Docket Number:	08-AFC-04C
Project Title:	Orange Grove Energy Project - Compliance
TN #:	203176
Document Title:	Walter Rusinek Comments: Comments of the Pala Band of Mission Indians on the Orange Grove Energy L.P.'s Response to Data Requests 1, 2, and 3
Description:	N/A
Filer:	System
Organization:	Walter Rusinek
Submitter Role:	Public
Submission Date:	10/7/2014 3:06:34 PM
Docketed Date:	10/7/2014

**Comments of the Pala Band of Mission Indians on the Orange Grove Energy L.P.'s
Response to Data Requests 1, 2, and 3**

Re: Comments of the Pala Band of Mission Indians on the Orange Grove Energy L.P.'s Response to Data Requests 1, 2, and 3 -- Petition for Post-Certification Amendment to Address Water Truck Complaints (No. 08-AFC-4C)

EXHIBIT A

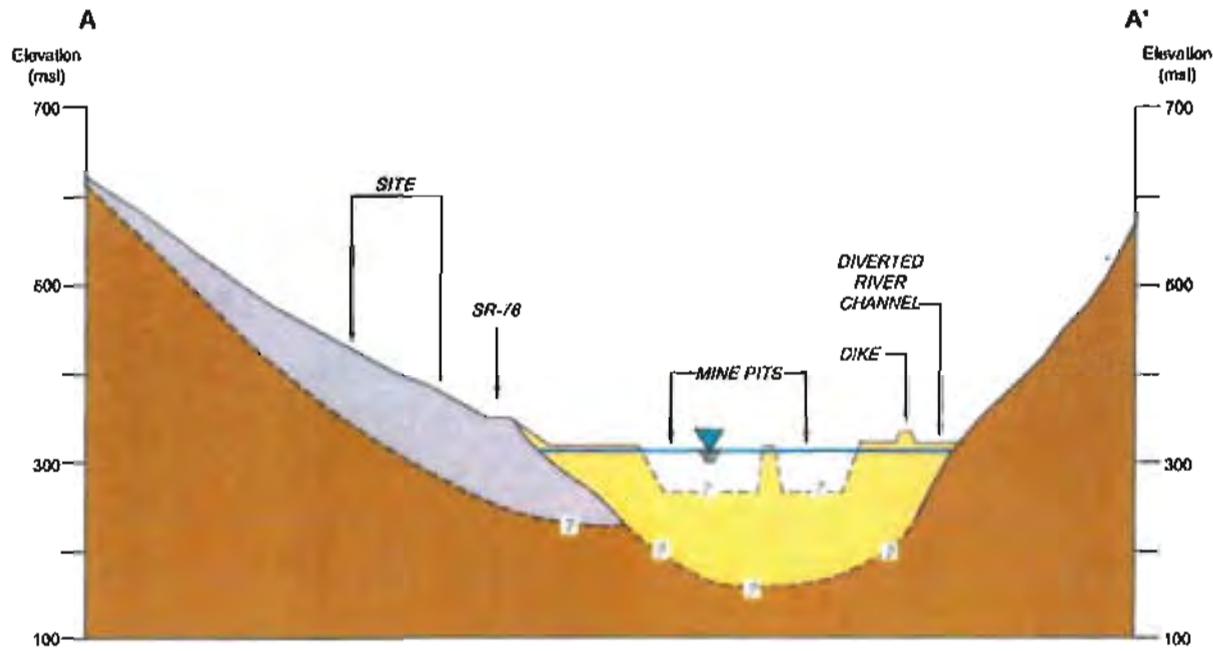
- Exhibit A, which was Exhibit K to the Pala Band's comments and Figure 6.5-4 from OGE's original application for certification, shows that the OGPP Property is not within the 100-year flood zone and thus that the OGPP Property does not abut the surface stream;

LOG OF EXPLORATORY BORING

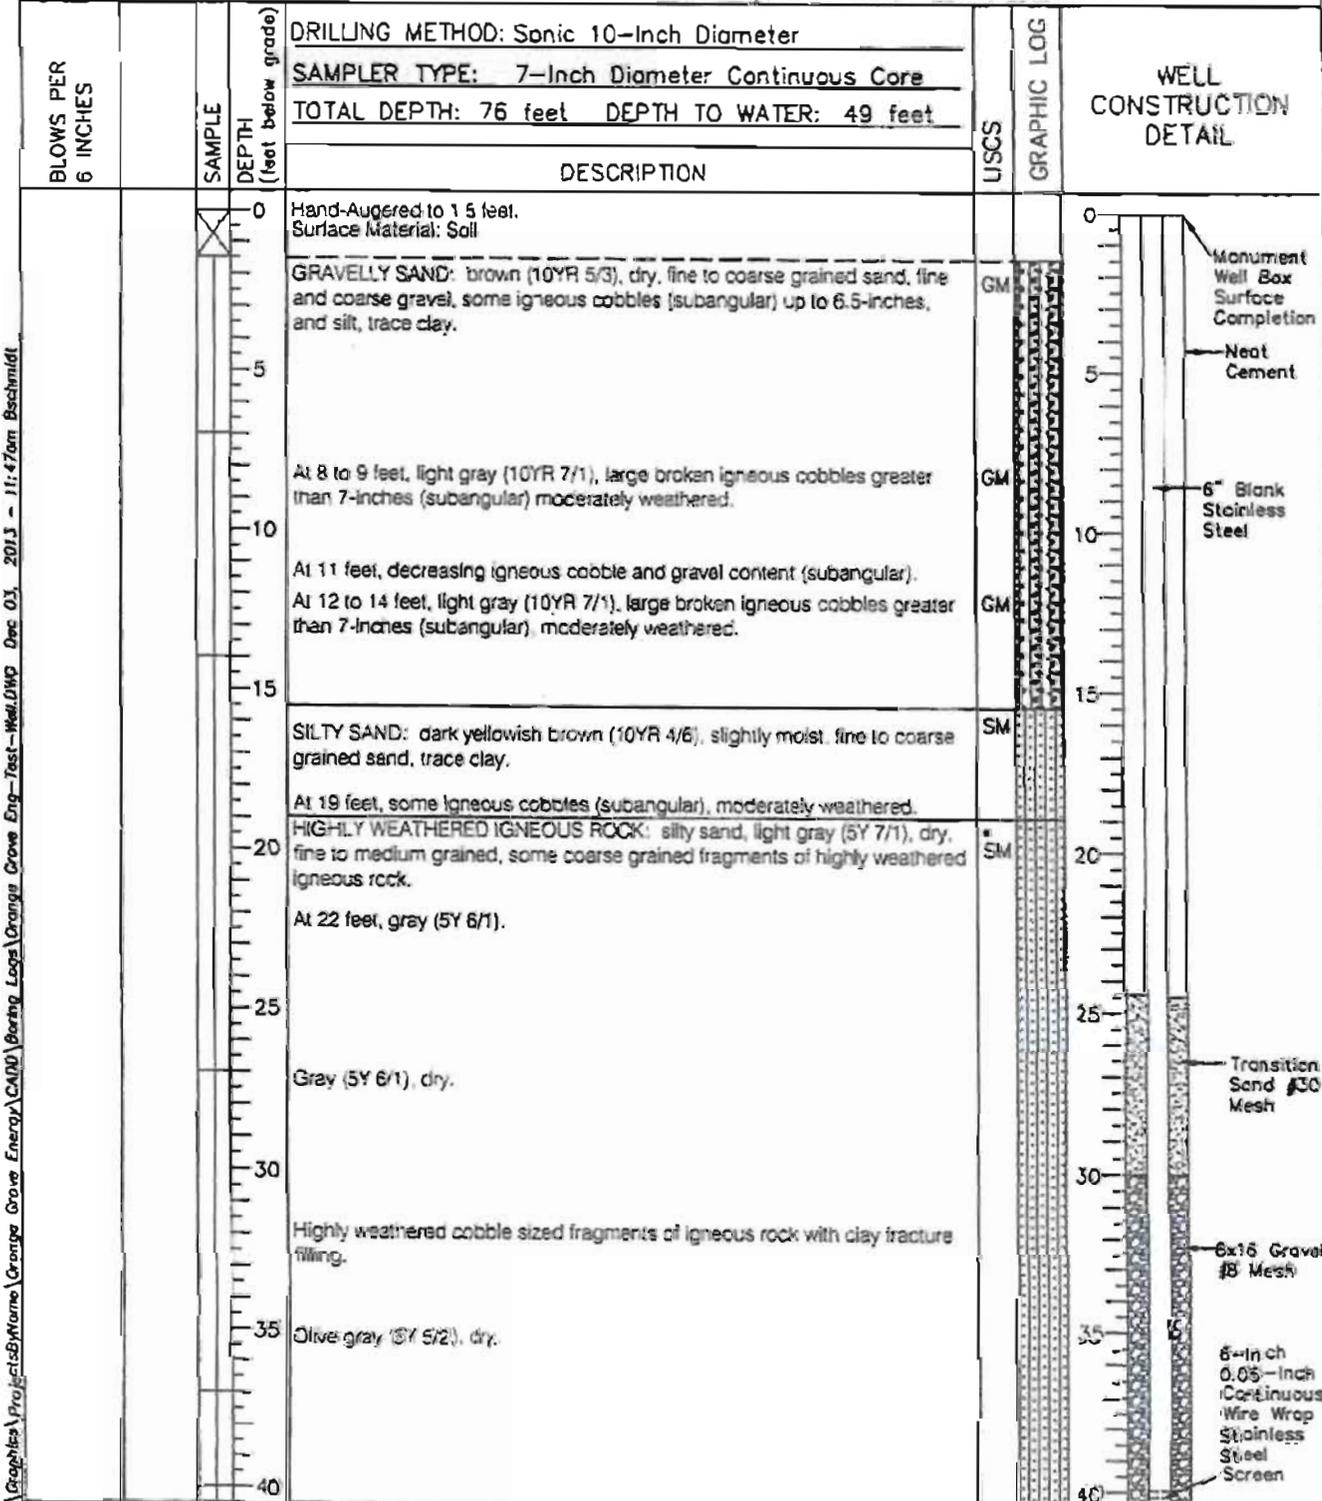
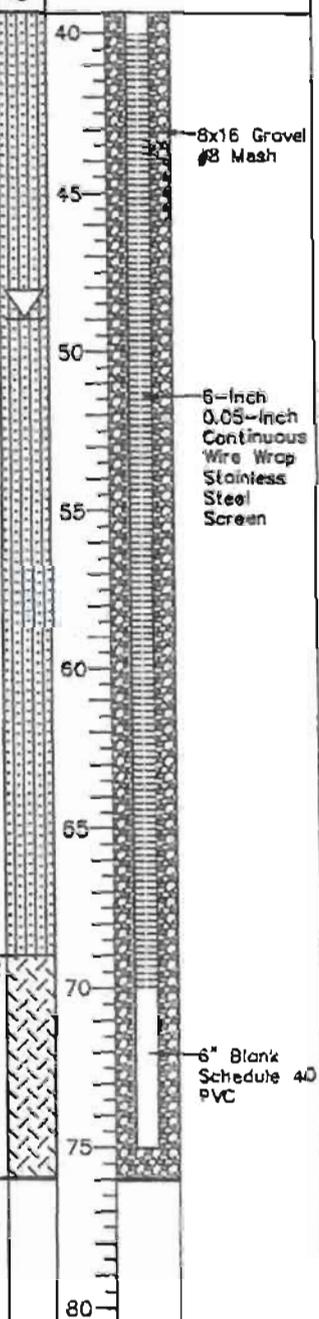
- Exhibit C, which was Exhibit M to the Pala Band's comments, is a "Test Well" report prepared by TRC Consultants for OGE which shows the location of the test well and the fact that the boring at the far south end of the OGPP Property encountered only weathered bedrock, not any of the water-bearing alluvium that constitutes the subterranean stream, meaning that the OGPP Property does not overlie or abut the subterranean stream. Any water found in that test well is percolating groundwater, not groundwater from the subterranean stream.
